Dalraddy to Slochd

Public Exhibitions Feb 2016
Summary Report

Transport Scotland

Client	Transport Scotland
Project	A9 Dualling Northern Section – Dalraddy to Slochd
Document title	Public Exhibitions February 2016 – Summary Report
Document reference	A9P11-AMJ-GEN-X_ZZZZZ_XX-RP-SE-0001

Junction constraints and options – Aviemore Central (A9/B9152)

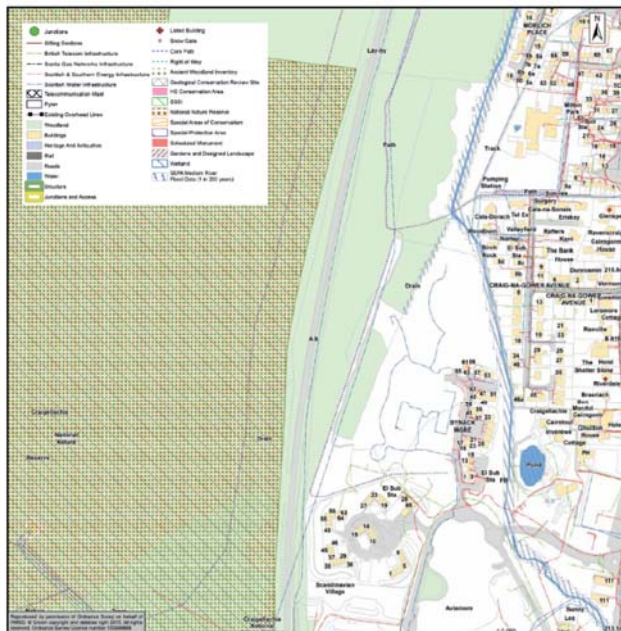
Reference	Comments
Aviemore_008	<p><u>Route Options and Junction Layouts</u></p> <p>Initial Response:</p> <ul style="list-style-type: none"> • Aviemore Central is a bad idea. • Traffic heading for the ski road increases congestion in the village. • This option also cuts off an access to the Macdonald resort and Scandinavian Village. • A combination of northbound and southbound widening should be used to keep the road away from existing housing. Widening on Northbound side will reduce costs for relocating water main. <p><u>Accesses</u></p> <ul style="list-style-type: none"> • At Aviemore South an access is needed to the Alltnacriche Outdoor Centre at the back of Linwilg. <p><u>Further responses:</u></p> <ul style="list-style-type: none"> • At the back of the Macdonald Resort, there is a large LPG installation. My concern is that there could be a potential safety hazard due to the very close proximity of the road. • The maps displayed at the exhibition do not show the new houses being built at the end of Grampian View. • The proposal for an "Aviemore Central" exit from the new road is totally bad planning. This also ignores the existing proposals for expansion of the village by 1500 homes on the Rothiemurchus side of the Spey. • We are concerned that should the dualling of the A9 involve cutting down more trees to the east of the road, the noise problem will get worse.

Aviemore_011	<p><u>Route Options and Junction Layouts</u></p> <ul style="list-style-type: none"> We were shocked that one of the options was for a brand new Central Junction which would bring all traffic into the middle of the village. The loss of the south junction would mean all traffic heading for and leaving the Cairngorm ski area would have to come through the village which is already congested. The proposed Central Junction would have to pass through a residential area with the added risk to young children. Also any major works in this area would exacerbate the flood risk from the Milton Burn.

Response	<p>Following the A9 Dualling Dalraddy to Slochd public exhibitions in Aviemore and Carrbridge in February 2016, thank you for taking the time to provide comments.</p> <p>The locations of junctions have been carefully considered. Feedback from public consultation including comments from the public exhibitions has been taken into account, together with factors such as proximity to property, environmental and geographical constraints, operational considerations, safety and cost in determining the preferred locations.</p> <p>Since the February exhibitions we have carried out an evaluation and identified the junction locations and junction layouts to be assessed as part of the Design Manual for Roads and Bridges (DMRB) Stage 2 Assessment.</p> <p>The evaluation considered engineering, environment and economic criteria and concluded that the potential junction location option at Aviemore Central has been discounted from further consideration. This option would have significant</p>

Reference	Comments
	<p>environmental impacts and would not provide significant benefits compared to the other locations considered.</p> <p>The junction locations now being taken forward for the project are at Aviemore South where the A9 connects with the B9152, at Granish (north of Aviemore) where the A9 connects with the A95 and B9152 and at Black Mount where the A9 connects with the A938.</p> <p>With respect to your comments about flooding, we confirm that we are obliged to ensure that the risk of flooding is not exacerbated by the dualling proposals. The impacts and required mitigation for flood risk will be fully assessed as part of the scheme development and used to inform any decisions with respect to the scheme in consultation with The Highland Council and Scottish Environment Protection Agency (SEPA).</p>
Aviemore_012	<p><u>Route Options and Junction Layouts</u></p> <ul style="list-style-type: none"> • South bound widening preferred - less impact on properties. • Cannot see the value of the Aviemore central access. This is not in keeping with the general aim to bypass town centres. • The southern access diverts Rothiemurchus and Cairngorm traffic from going through the village. • The Granish interchange design must avoid HGVs crossing lanes to join or leave the A9.
